City of North Miami Beach, Florida
ADMINISTRATIVE SERVICES

ADDENDUM NO. 3
March 17, 2009
INVITATION TO BID

SUBJECT: PROVIDE GENERATOR AND FURNISH ALL MATERIALS, LABOR, EQUIPMENT, TOOLS AND INCIDENTALS TO INSTALL THE GENERATOR AND COMPLETE THE CITY HALL GENERATOR REPLACEMENT PROJECT

BID NUMBER: #2009-05

E-12

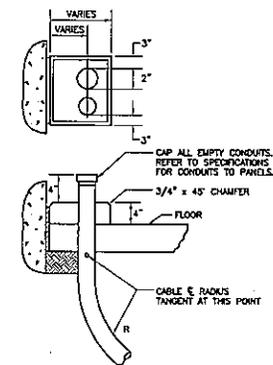
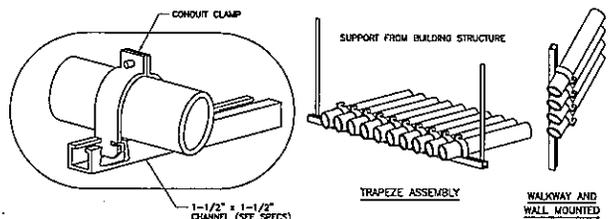
- Comment No. 1 Provide manhole sump pump specification and piping specification.
- Response No. 1 Refer to revised sheet E-12 issued in this addendum.
- Comment No. 2 24 Volt starting systems

4
E-12
DETAIL OF CONDUIT TERMINATION STUB OUT
N.T.S.

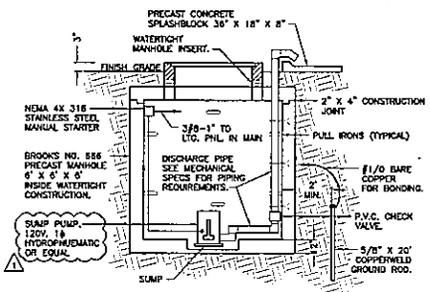
Comment No. S Detail for outdoor housekeeping stub ups.

Response No. 8 Refer to revised sheet E-12 issued in this addendum.

6
E-12
BOLLARD POST DETAIL
N.T.S.

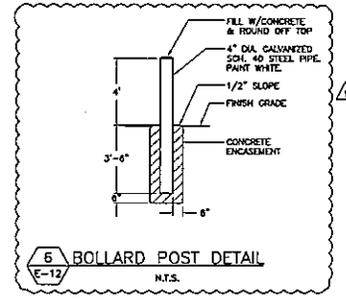
- Comment No. 4 Are there any details on concrete bollard-depth, etc.?
- Response No.4 Refer to revised sheet E-12 issued in this addendum.
- Comment No. 5 Will FPL or the Contractor be responsible for the transformer slab?
